**PLANNING COMMISSION AGENDA
APRIL 7, 2022 – 6:30 P.M.**

**CITY OF LA VISTA
PLANNING DIVISION
RECOMMENDATION REPORT**

NEBRASKA MULTI-SPORT COMPLEX
SITE & INFRASTRUCTURE PLANS

Figure 4. Existing Intersection Capacity Analysis

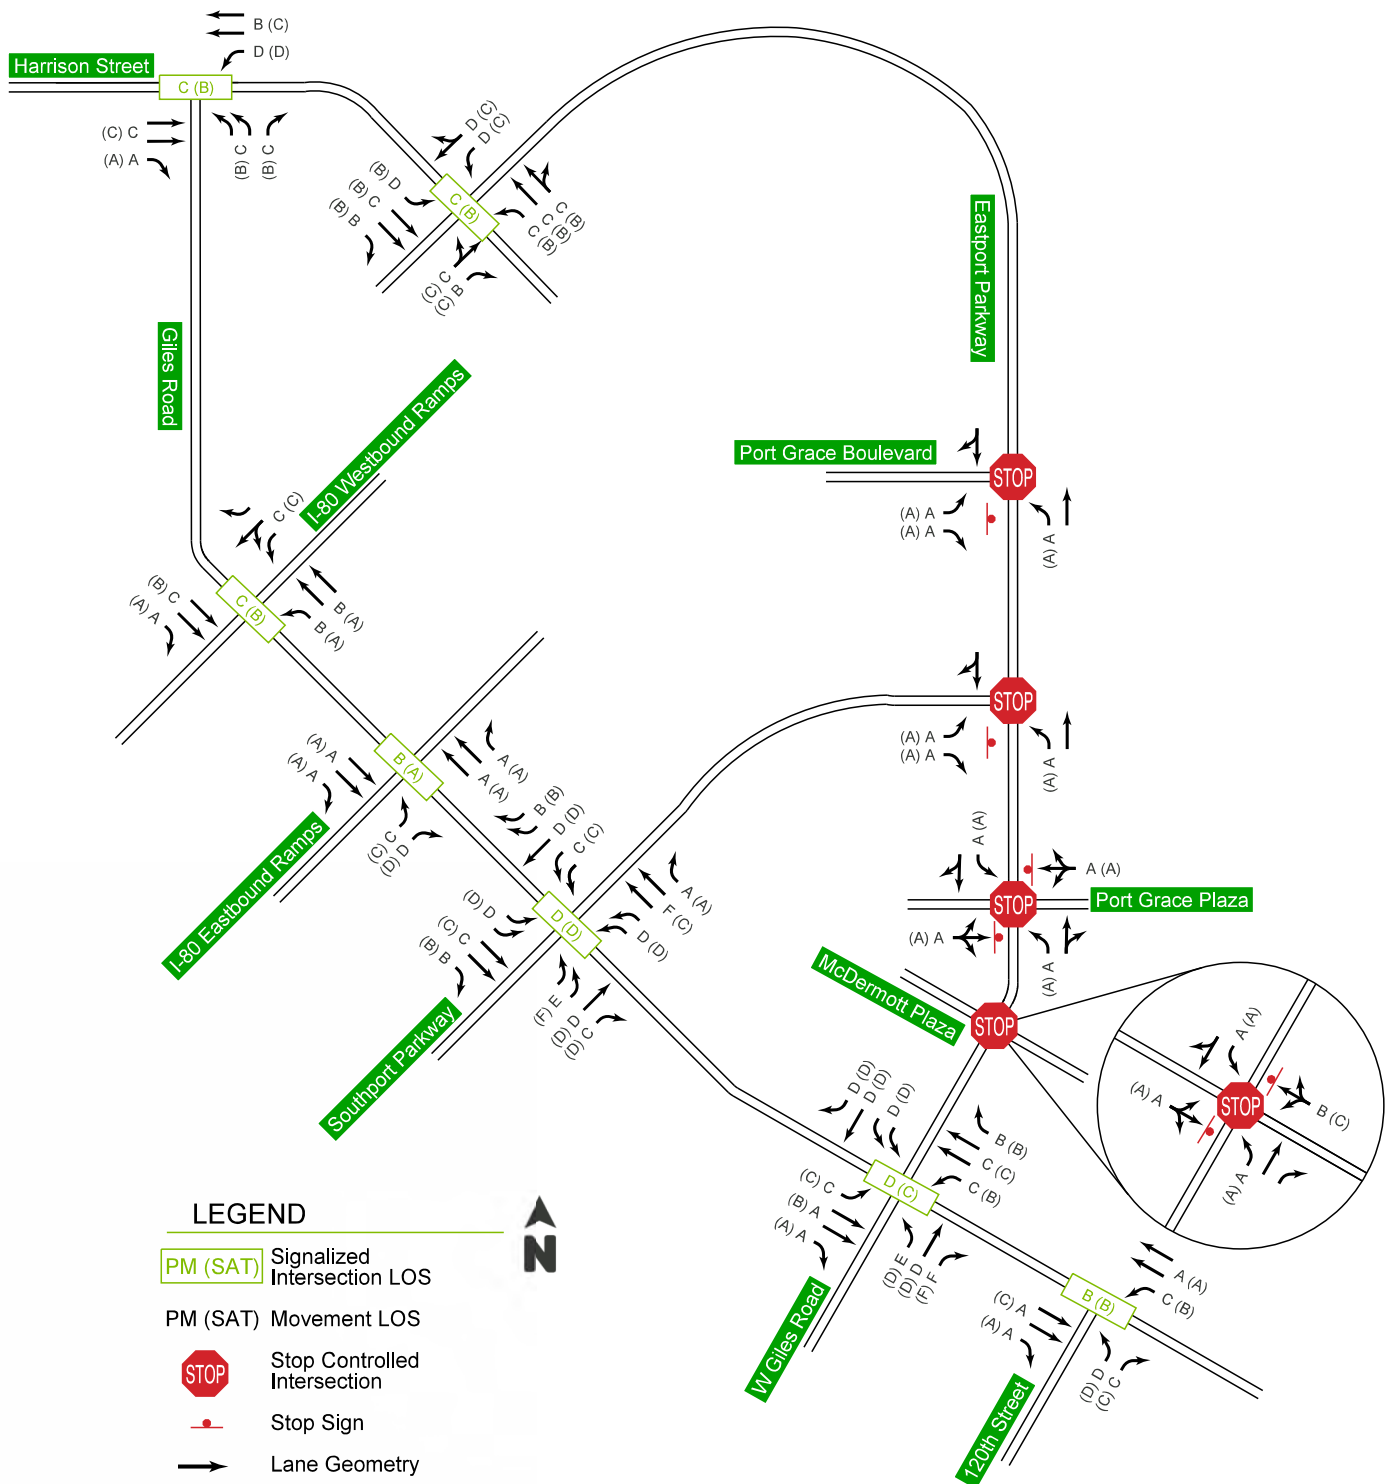
3. Page 6, 7 & 8 / Table 3 & Figure 4: LOS and movements do not match between text, table, and figure. Examples include the text states the “intersection of Giles Road and West Giles Road /Eastport Parkway which operates at LOS F in the PM peak hour” when Figure 4 show is at LOS D. Figure 4 shows E (D) for the eastbound left-turn at Giles and Southport, but text and table show E (F). The westbound through movement of Giles at Southport is also LOS F in the PM peak.
Please have the applicant update the text, table, or figure with the correct LOS.

Figure 7. 2025 Background Intersection Capacity Analysis

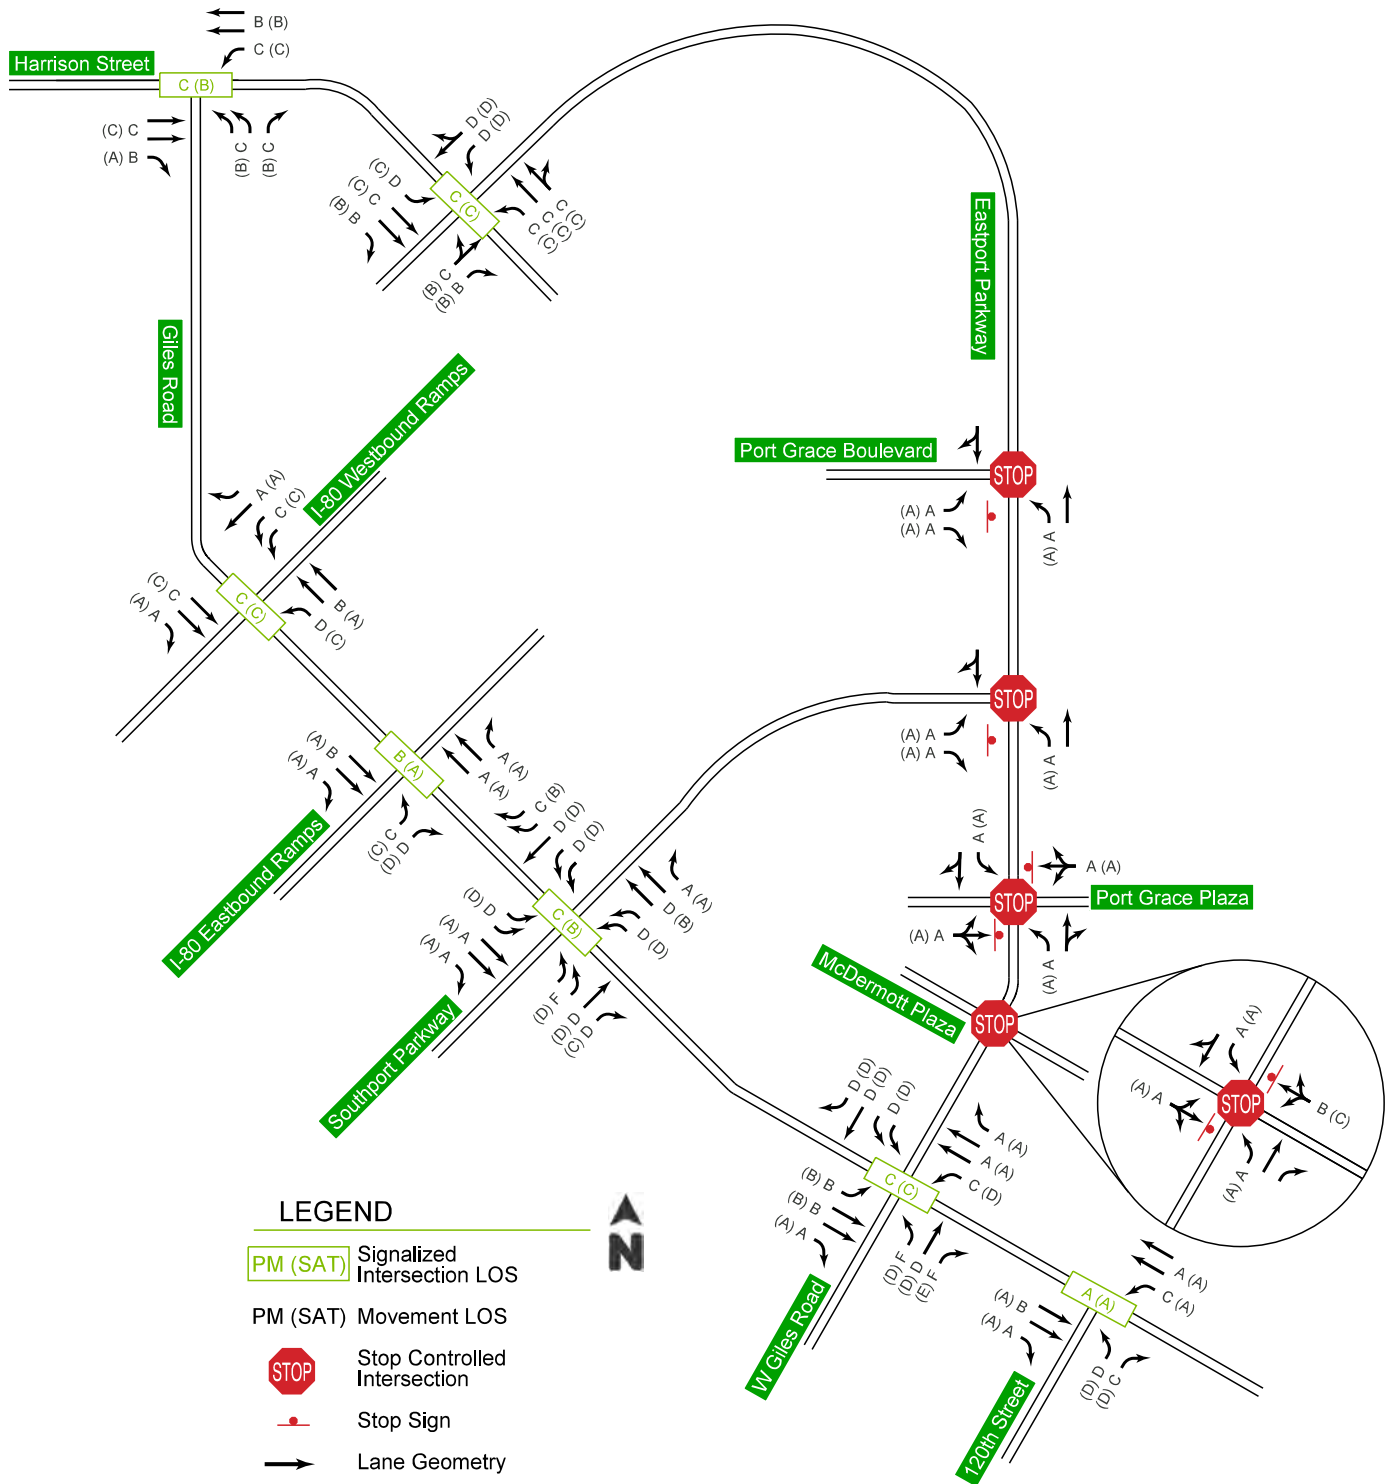
4. Page 8 & 14 / Figure 4 & Figure 7: Overall intersection LOS and individual movement LOS at the intersection of Giles Road with Southport Parkway improve from Existing [D (D)] to 2025 Background [C (B)].
Please have the applicant verify the LOS for 2025 Background with the modified phase splits.

Figure 8. 2050 Background Intersection Capacity Analysis.

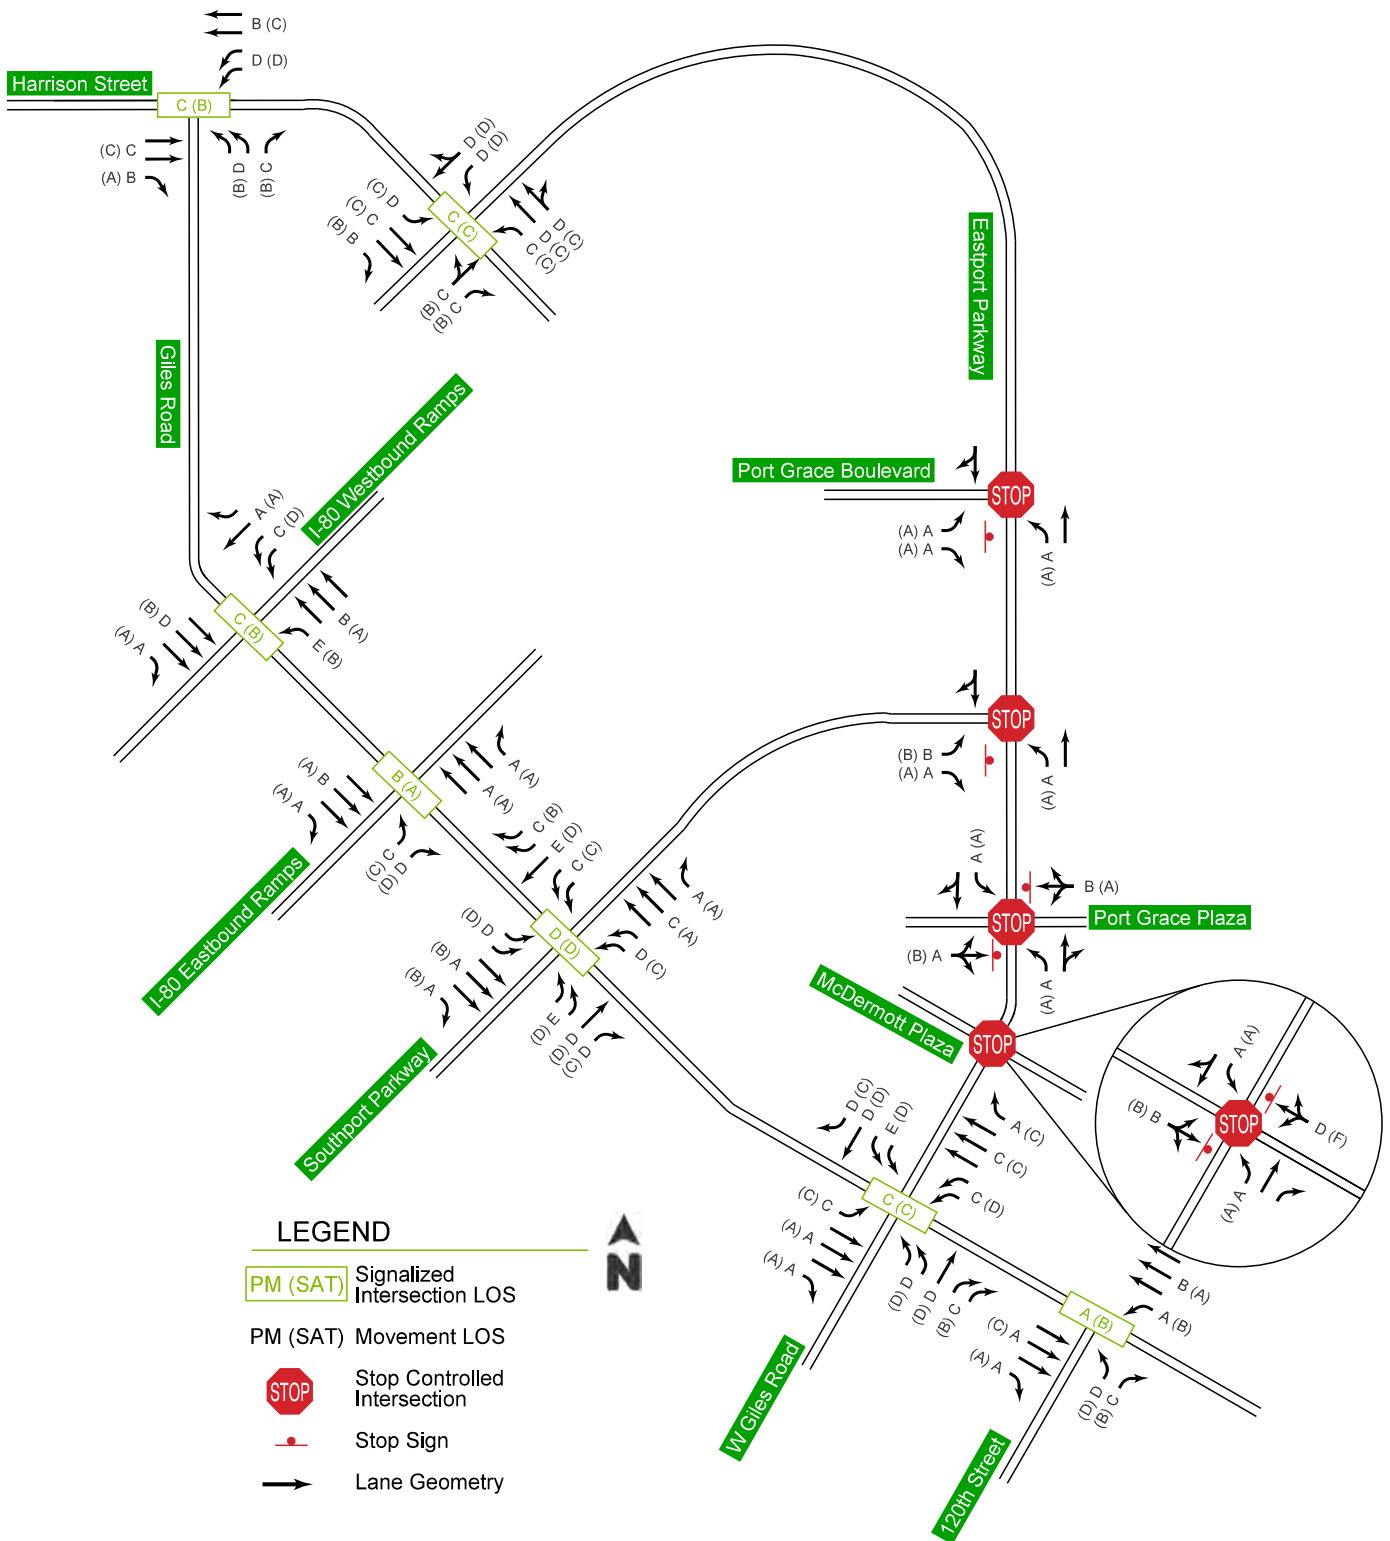
6. Page 15 & 17/ Figure 8: Dual westbound left-turn lanes are assumed to be included as part of the 2050 Background improvements. Figure 8 shows a single westbound left-turn lane on Harrison Street.
Please have the applicant show the correct lane arrangements and update the operational analysis at the intersection of Giles Road with Harrison Street for 2050 Background.

7. Page 16 & 17 / Table 5 & Figure 8: Figure 8 shows the northbound left-turn movement on Giles Road at the I-80 Westbound Ramps as LOS E in the PM peak hour.
Please have the applicant add this movement, queues, delay, and V/C ratio to Table 5.

Figure 9. Site plan

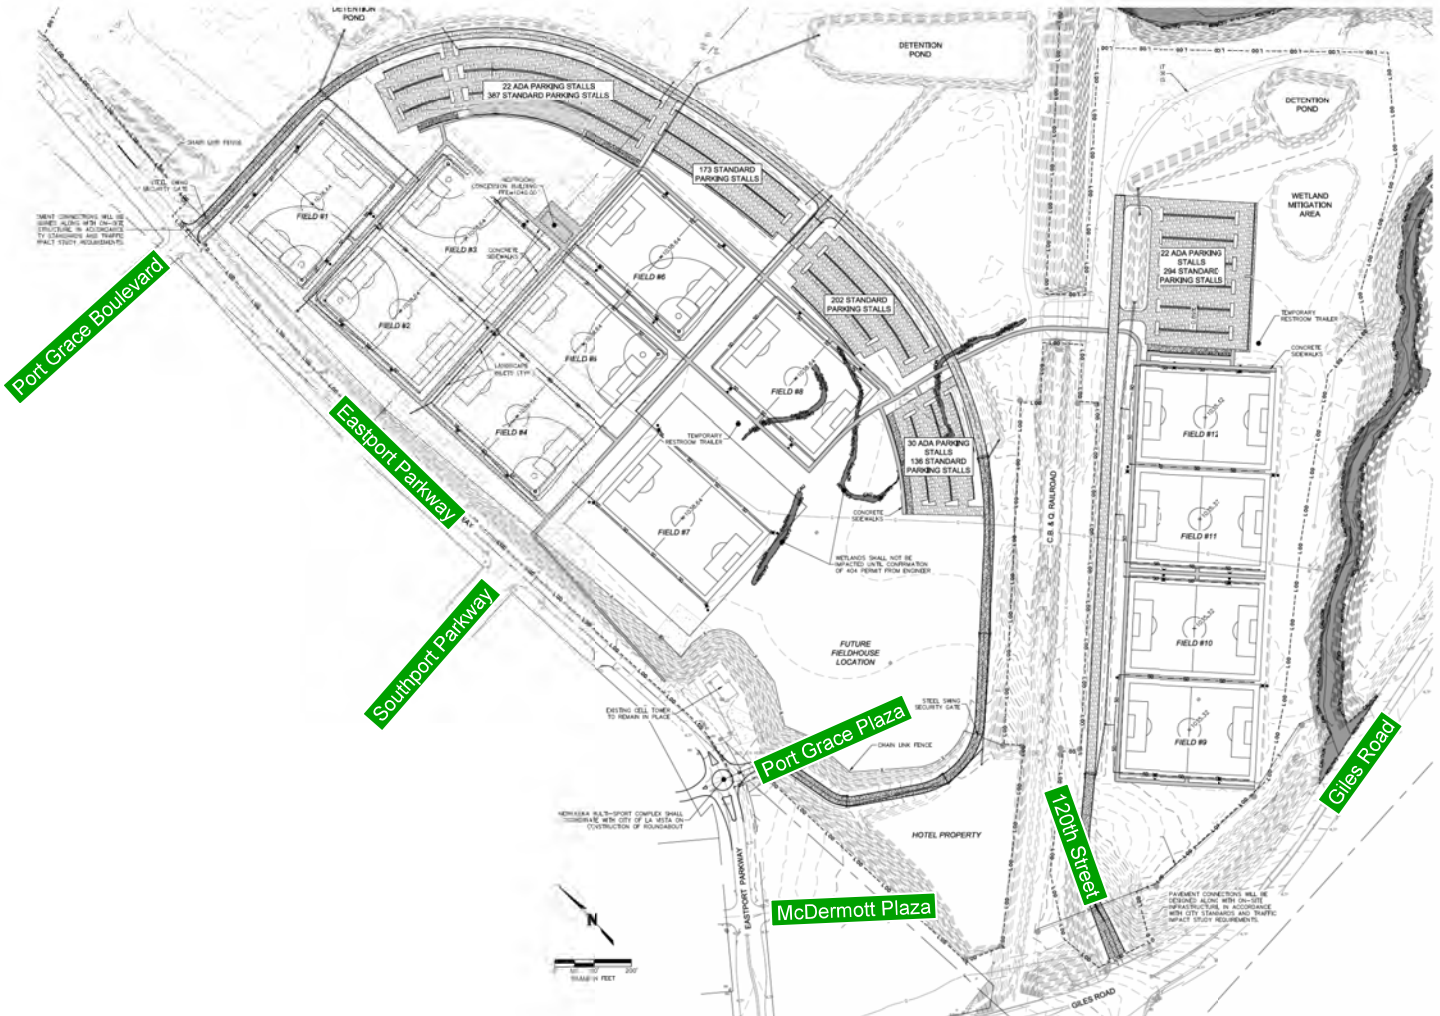
5. Page 19 / Figure 9: The site plan does not show parking lot locations, the grade-separated pedestrian bridge, the stadium field, or the standalone fieldhouse.
Please have the applicant include a revised site plan showing the locations of these facilities.
